Vogtle Electric Generating Plant
Request for Technical Specification Amendment
Containment Tendon Surveillance Program

**Vogtle Electric Generating Plant
Request for Technical Specifications Amendment
Containment Tendon Surveillance Program**

Marked-Up Technical Specifications and Bases Pages

Figure 5.5.6-1 Schedule of Lift-Off Testing for Two Containments at a Site

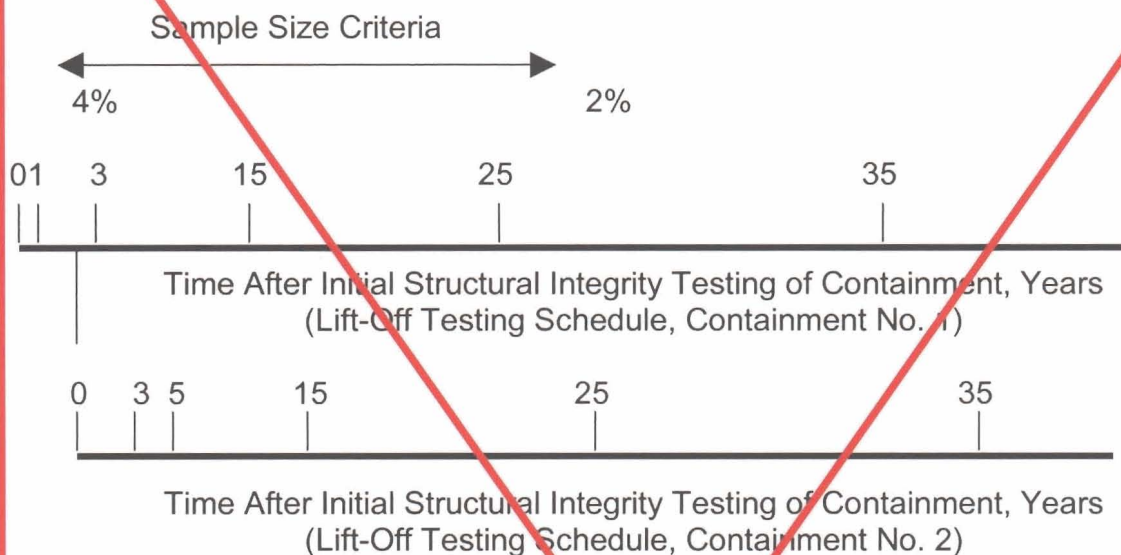
In addition, a deletion of Figure 5.5.6-1 is proposed since the lift-off testing schedule is per an NRC approved alternative contained in the Unit 1 and Unit 2 Containment Inservice Inspection Program Plan.

DELETE FIGURE 5.5.6-1

5.5.6-1	Deleted.
